PARTIAL PLUMBING SITE PLAN

CHANGE ORDER # 03

RESTROOM BUILDING
RELOCATABLE CLASSROOMS

BAKERSFIELD CITY SCHOOL DISTRICT
BAKERSFIELD, KERN COUNTY, CALIFORNIA

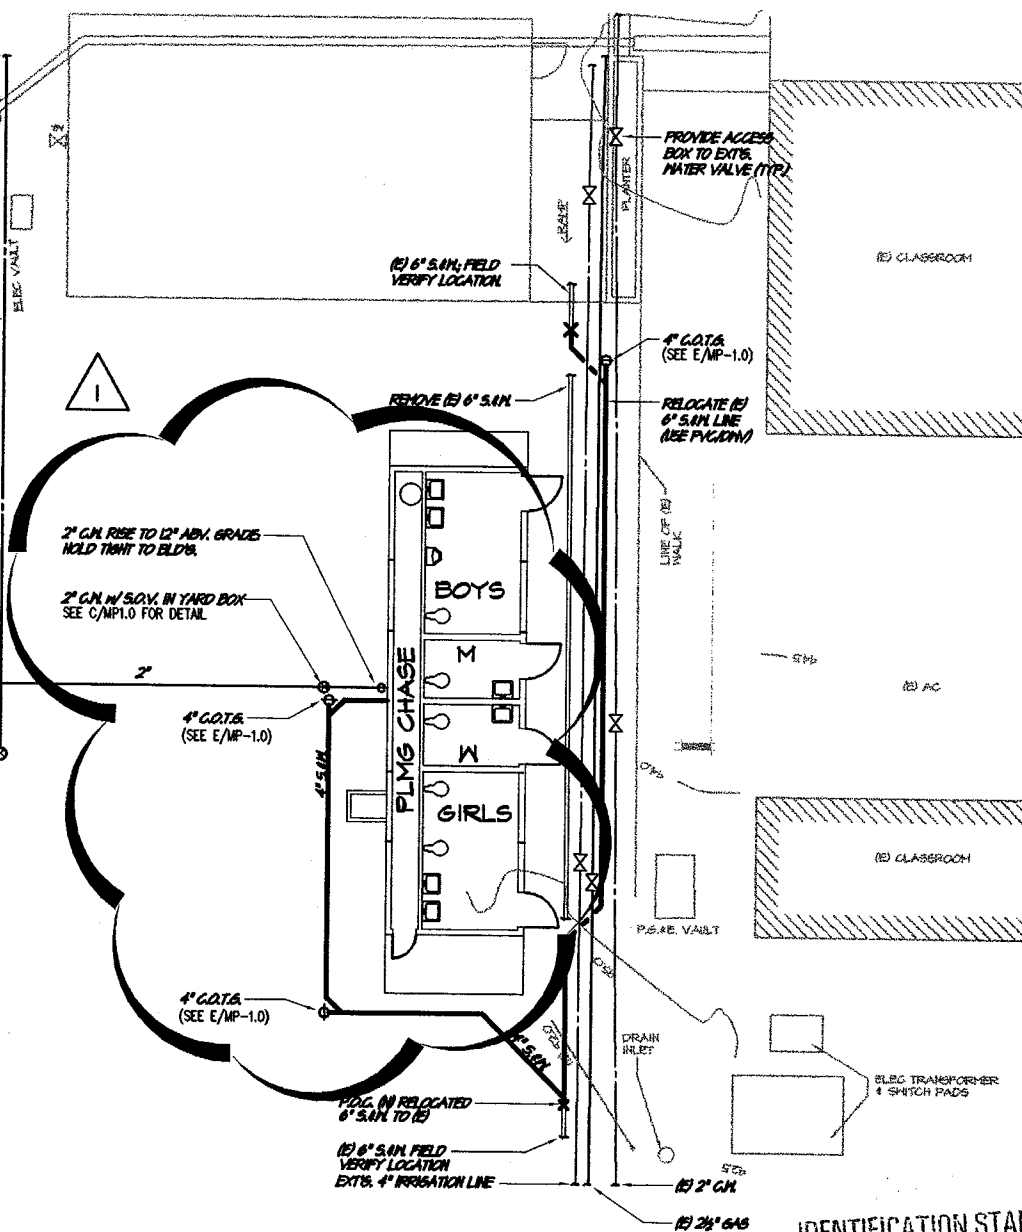
3" SCHEDULE 40 P.V.C.
C.H. TO METER
LOCATION (SEE A/1.0)

ROUTE AROUND (B)
VAULTS, DRAINS, ETC.

1/4" S.O.V. IN YD. BOX
FOR FILL PORTABLES
(SEE C/MP-1.0)
